Model: T-MF1		Date: 5-Jun-08	No.: MJ012001
Modified Article: Part Catalog Correction		Prepared by: Y.Murata	
From: Technical Services sec. Service Planning Dept.			
Reason for Modification:	☒ Parts catalog correction ☐ To facilitate assembly ☐ Part standardization	☐ Vendor change ☐ To improve reliability ☐ Other ()	☐ To meet standards ()
Modification Schedule:

Model: T-MF1		Date: 14-Jul-08	No.: MJ012002
Modified Article: Plotter unit		Prepared by: Y.Murata	
From: 1st Tech. Support Sec. Service Support Dept.			
Reason for Modification:	☐ Parts catalog correction ☐ Vendor change ☒ Other ☐ To facilitate assembly ☐ To improve reliability ☐ To meet standards ☐ Part standardization ☐ Product Safety ()

Model: T-MF1		Date: 26-Aug-08	No.: MJ012003
Modified Article: End/Side Fence		Prepared by: Y. Murata	
From: 1st Tech. Support Sec. Service Support Dept.			
Reason for Modification:	☐ Parts catalog correction	☐ Vendor change	☐ Other
	☐ To facilitate assembly	☒ To improve reliability	☐ To meet standards
	☐ Part standardization	☐ Product Safety	()

Model: T-MF1		Date: 26-Aug-08	No.: MJ012004
Modified Article: Paper tray unit		Prepared by: Y. Murata	
From: 1st Tech. Support Sec. Service Suppo

Old P/N	New P/N	Description	Q'ty	Int	Page	Index	Note
J0123003	J0123006	END FENCE: T-MF1	1	O/O	11	2	
J0123004	J0123040	SIDE FENCE:LEFT: T-MF1	1	O/O	11	7	
J0123005	J0123050	SIDE FENCE:RIGHT: T-MF1	1	O/O	11	8

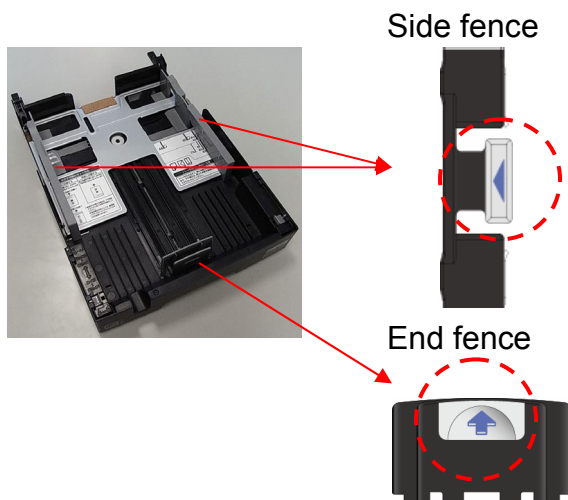
- 1) The symbols shown below were added to the side fence and end fence.
- 2) The shape of the end fence was changed.

- 1) To make the operation of the fence more understandable.
- 2) To further increase the strength of the end fence.

-Illustration-

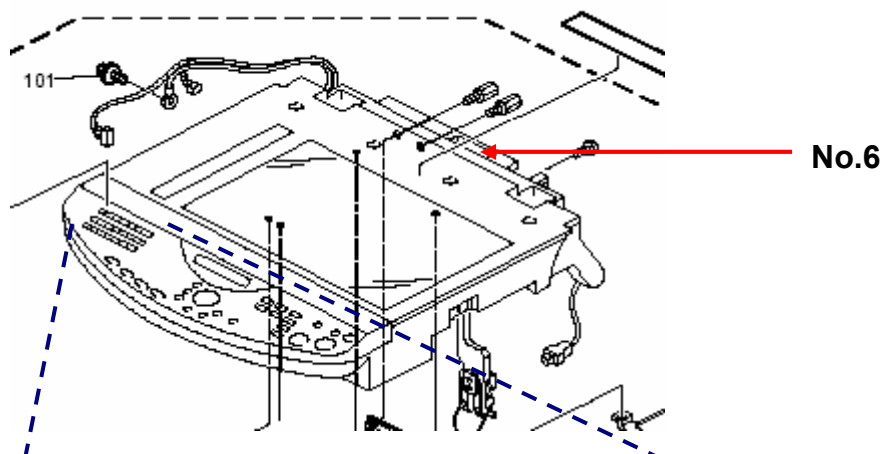
Old P/N	New P/N	Description	Q'ty	Int	Page	Index	Note
-	J0127030	COVER:SCANNER:REAR(T-MF1a)	1	-	9	6	-
-	J0137030	COVER:SCANNER:REAR(T-MF1b/bN)	1	-	9	6	-
-	J0137031	Decal: DIAL	1	-	9	7	-
-	J0137032	Plate: DIAL	1	-	9	8	-

Change/Reason: Newly added the following parts.
